# UNITED STATES PATENT AND TRADEMARK OFFICE

APPLICATION NO.	FILING DATE	FIRST NAMED INVENTOR	ATTORNEY DOCKET NO.	CONFIRMATION NO.
10/821,735	04/08/2004	Michael E. Ring	MER 04069	1527
<div>7590 JAMES RAY &amp; ASSOCIATES 2640 Pitcairn Road Monroeville, PA 15146</div>			<div>EXAMINER LE, MARK T</div>	
			<div>ART UNIT 3617</div>	<div>PAPER NUMBER</div>
			<div>MAIL DATE 10/19/2007</div>	<div>DELIVERY MODE PAPER</div>

<b>Office Action Summary</b>	<b>Application No.</b> 10/821,735	<b>Applicant(s)</b> RING, MICHAEL E.	
	<b>Examiner</b> Mark T. Le	<b>Art Unit</b> 3617

### **DETAILED ACTION**

FIG. 7

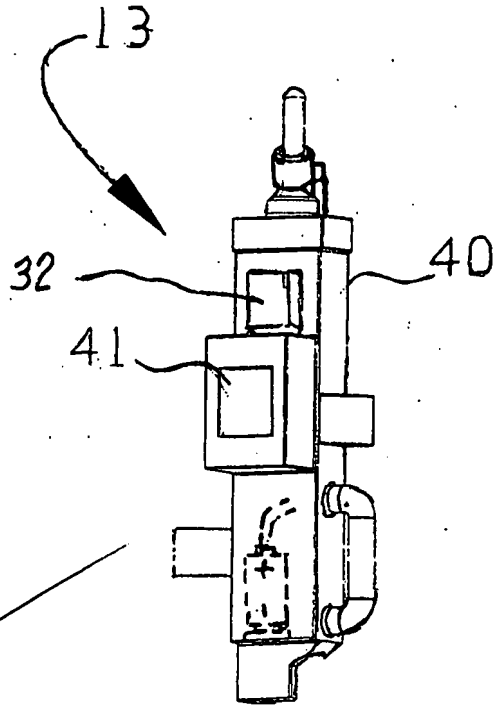
2. The replacement sheet of drawing Fig. 7 is not approved for entry because the specific arrangement of the elements of EOT device, as shown in the proposed Fig. 7, is not supported by the originally filed disclosure. To correct this problem, Applicant is suggested to provide a new drawing showing the EOT device and the associated elements in the form of a box diagram, which includes rectangular boxes representing the EOT device and the components thereof or associated therewith. Since the proposed drawing correction filed on September 14, 2007 has not been approved for entry, the previous objections to the drawings are again repeated below.

not  
approved  
for  
entry  
10/16/07  
*[Signature]*
